## **Gatwick Airport Northern Runway Project**

Examination Ref: TR020005

# **Joint local Authorities Response to the Applicants Deadline 5 Submissions**

Deadline 6: 26 June 2024

**Figure 1: Location of Contractor Compounds**

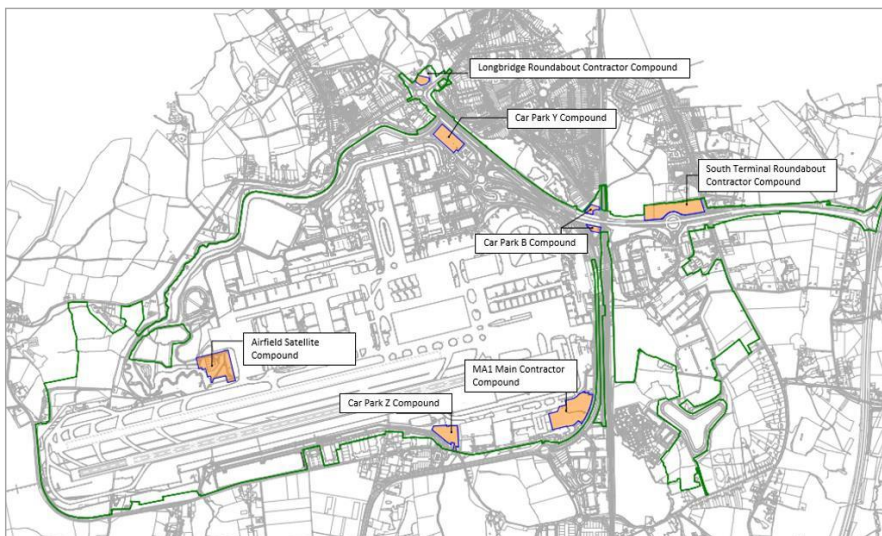
**Commented [SS10]:** Does the Reed Bed Treatment System Compound, introduced under Project Change 3 need to be included within this section of the plan and figure 1 updated?

**Figure 3: Key Active Travel Routes around Gatwick Airport**

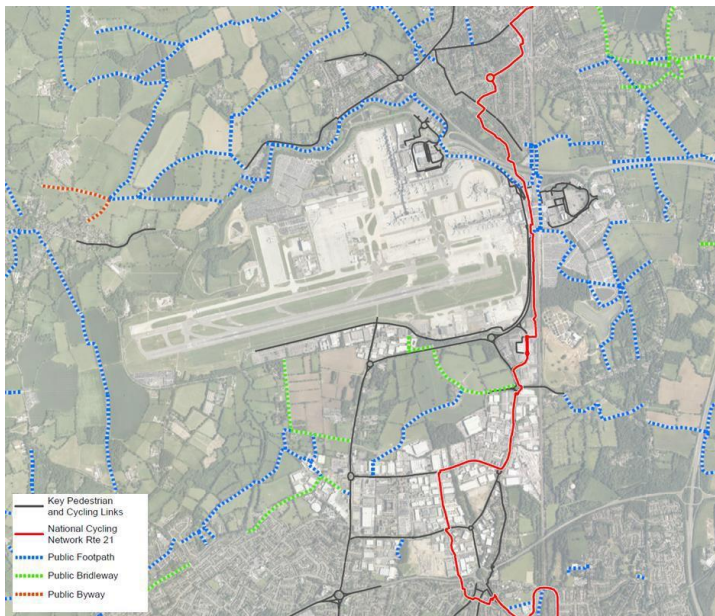
**Commented [MG13]:** Much improved cycling connections will be required for these facilities to be used at virtually all of the compounds.
